P-9173-5
29395

ISSUE-2

NAME	DATE
JINDAL SYMBOL OF QUALITY AN ISO 9001 COMPANY	*JINDAL ALUMINIUM LTD.* *BANGALORE-560073 (INDIA)*	DRAWN	J.P.KAUSHIK	25-09-2010
		CHECKED		
		APPROVED	S.S.GARG	04-11-2010
1. ALL DIMENSIONS ARE IN mm. 2. ROUND OFF ALL SHARP CORNERS WITH 0.40 mm. 3. TOLERANCES WILL BE AS PER BS:EN-755 UNLESS OTHERWISE SPECIFIED		SCALE		1:1
		AREA mm^2		2812.737
		PERIMETER mm.		1119.659
		WEIGHT kg/m		7.594
PARTY'S NAME	KOSAN CRISPLANT LANKA PVT. LTD.,SRI LANKA	DRAWING No.		SECTION No.
PARTY'S DRAWING No.	332B935 REV.02	P-9173-5		–
ALLOY & TEMPER	AlMgSi 0.5 (EN AW 6060 TF) (6060 T6)	29395		29395(ISSUE-2)
DESCRIPTION	MISC. SECTION

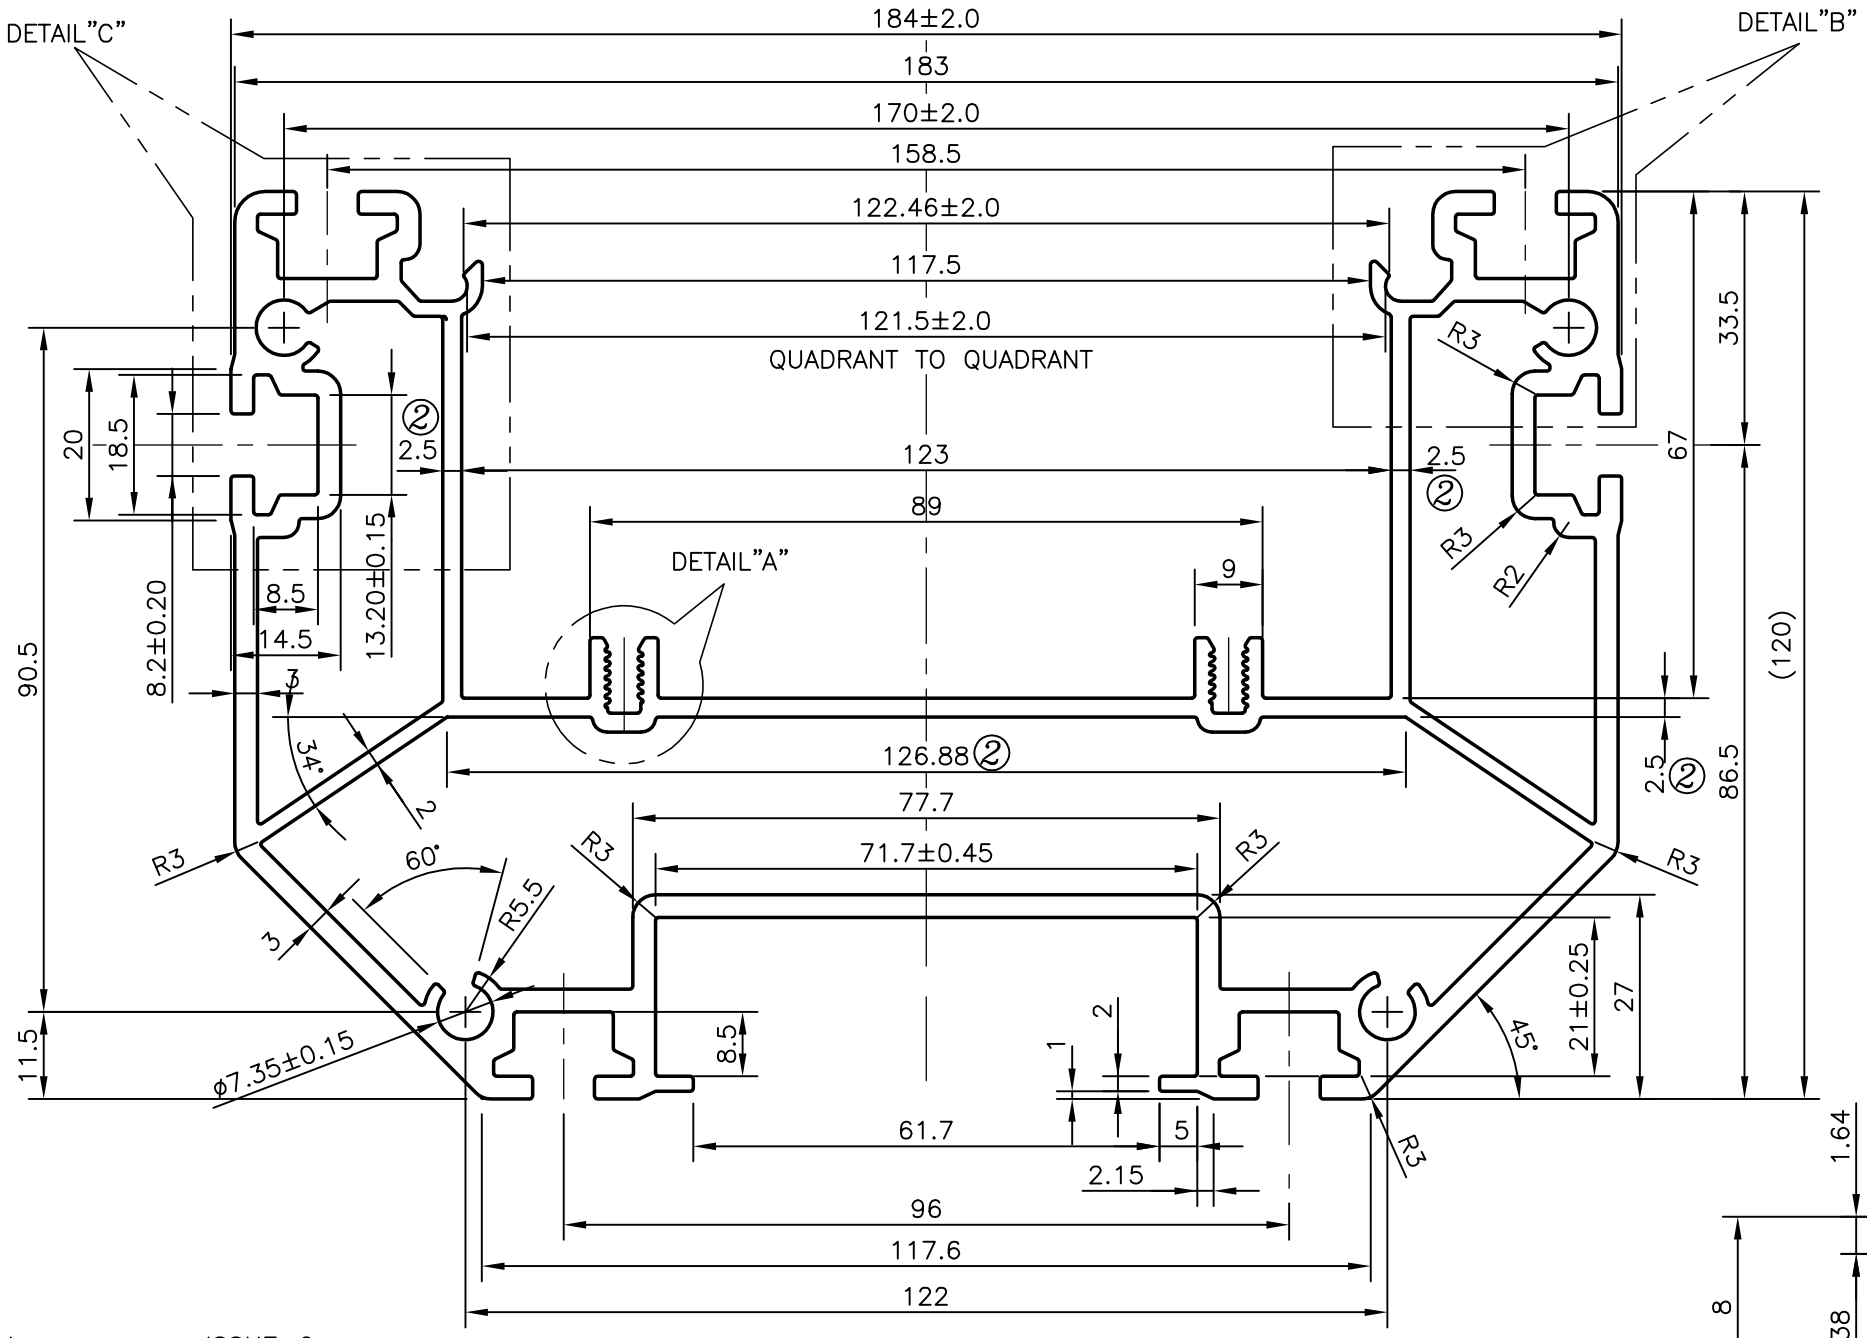
THICKNESS CHANGE FROM 2.0mm TO 2.5mm & DIMENSIONS CHANGED FROM 125.4 TO 126.88

WEIGHT ALSO CHANGED FROM 7.287 kg/M TO 7.594 kg/M
